STAFF REPORT
COMMUNITY DEVELOPMENT DEPARTMENT

HEARING DATE: March 16, 2023
 TO: Planning & Zoning Commission
 FROM: Sonya Allen, Associate Planner
 208-884-5533
 SUBJECT: H-2022-0082
 Delano Apartments CUP
 LOCATION: 3850 N. Centrepoint Way, in the SE 1/4
 of Section 32, T.4N., R.1E. (Parcel
 #R1798151400)

Conditional Use Permit for a multi-family development consisting of 84 dwelling units on 3.49 acres of land in the R-40 zoning district.

AS1.1
OPEN SPACE EXHIBIT

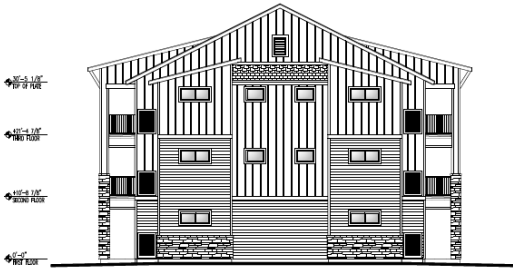
A total of 28,185 square feet (or 0.65-acre) of common open space is proposed consisting of a 5,000 s.f. central common open space area and common areas of at 20' x 20' in area as depicted on the open space exhibit in Section VIII.C.

Common open space shall be not less than four hundred (400) square feet in area, and shall have a minimum length and width dimension of twenty feet (20'). *The common open space areas depicted on the open space exhibit in Section VIII.C meet this requirement.*

Unless otherwise approved through the conditional use process, common open space areas shall not be adjacent to collector or arterial street buffers unless separated from the street by a berm or constructed barrier at least four feet (4') in height, with breaks in the berm or barrier to allow for pedestrian access. (Ord. 09-1394, 3-3-2009, eff. retroactive to 2-4-2009) ***Some of the common open space is located adjacent to a collector street (Centrepont Way) – Commission approval is needed in order for these areas to qualify toward the open space requirement. The two (2) northern areas depicted on the open space exhibit aren't really recreation areas but the southern area where the pickleball court is proposed is. Therefore, if approved by the Commission, Staff recommends a berm or constructed barrier is constructed between the pickleball court and the street buffer in accord with this requirement.***

7. Provide a minimum of 0.65-acre of qualified open space as shown in the open space exhibit in Section VIII.C that complies with the standards listed in UDC [11-4-3-27C](#).

- g. **Common open space areas shall not be adjacent to collector or arterial street buffers unless approved by the Commission.** If approved, the common area on the southwest portion of the site where the pickleball court is located shall be separated from the street by a berm or constructed barrier at least four feet (4') in height, with breaks in the berm or barrier to allow for pedestrian access in accord with UDC [11-4-3-27C.7](#).

AA5.0
 BUILDING ELEVATIONS

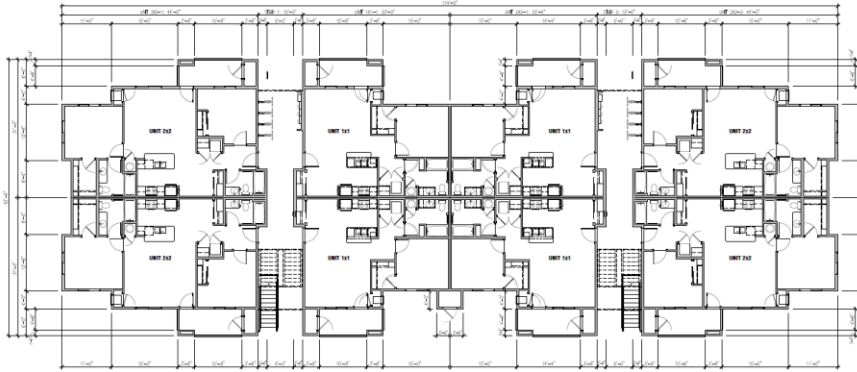
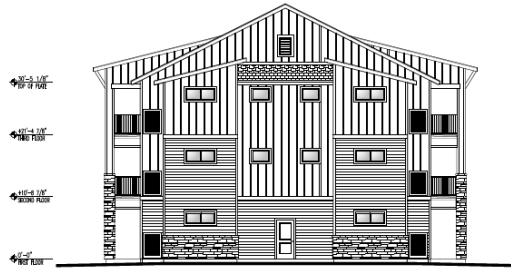
Compliance application should depict landscaping along the street facing elevation of Building A adjacent to N. Centrepoint Way in accord with these standards. Landscaping is required to be provided along all pathways per the standards listed in UDC 11-3B-12C. Street buffer landscaping along N. Centrepoint Way, a collector street, was installed with the subdivision improvements.

Building Elevations ([UDC 11-3A-19](#) | [Architectural Standards Manual](#)): Conceptual building elevations of the multi-family structures were submitted with the annexation application for Delano subdivision as shown below. The existing Development Agreement (DA) requires future development to be generally consistent with those elevations and comply with the design standards in the Architectural Standards Manual.

While the *style* of the proposed elevations is not really consistent with the conceptual elevations included in the DA, they are consistent in *form* in that they are both 3-stories in height with balconies and patios for each unit with a variety of materials and have similar modulation. The proposed elevations have pitched roofs with architectural asphalt shingles, vertical fiber cement board and batten siding, fiber cement horizontal lap siding with stone wainscot accents. Staff is of the opinion the proposed design is preferable as it’s more consistent with the style of residential structures in the surrounding area and will blend better. Therefore, Staff does not recommend a modification to the DA.

Final design of all structures is required to comply with the design standards in the Architectural Standards Manual and will be reviewed for compliance with these standards with the Design Review application. **Compliance with the building code requirements for separation between structures within the development is required.**

- c. Depict landscaping along the foundation of the street facing elevation of Building A adjacent to N. Centrepoint Way as set forth in UDC [11-4-3-27E.2](#).

11. A Certificate of Zoning Compliance and Design Review application shall be submitted and approved for the proposed use prior to submittal of a building permit application. The design of the site and structure shall comply with the standards listed in UDC [11-3A-19](#) and the design standards listed in the *Architectural Standards Manual*.

SHEET
SD2.2
FLOOR PLANS

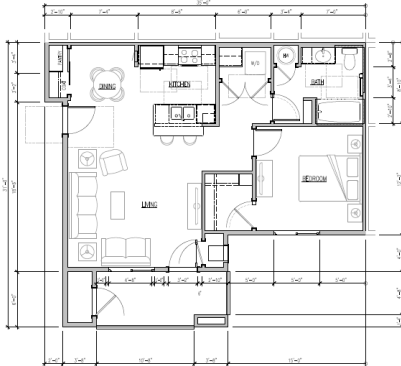
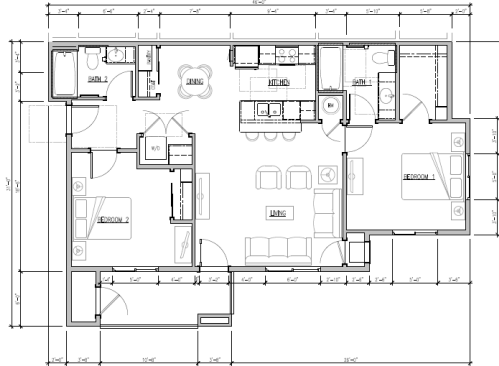
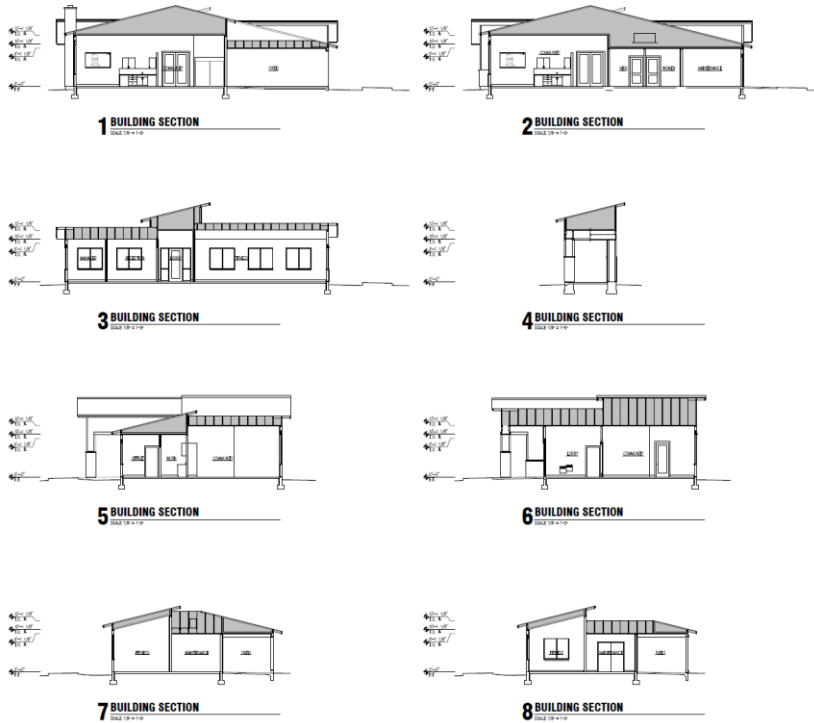
3. A minimum of eighty (80) square feet of private, usable open space shall be provided for each unit. This requirement can be satisfied through porches, patios, decks, and/or enclosed yards.

Landscaping, entryway and other access ways shall not count toward this requirement. In circumstances where strict adherence to such standard would create inconsistency with the purpose statements of this section, the Director may consider an alternative design proposal through the alternative compliance provisions as set forth in section [11-5B-5](#) of this title. *The site plan states a minimum of 80 square feet of private usable open space will be provided for each unit in the form of decks and patios as depicted on the floor plans (see Sections VII.A and D).*

2. The multi-family development shall have an ongoing obligation to comply with the specific use standards listed in UDC [11-4-3-27](#).
3. Submit floor plans demonstrating compliance with the minimum private usable open space standard of eighty (80) square feet for each unit in accord with UDC [11-4-3-27B.3](#) with the Certificate of Zoning Compliance application.
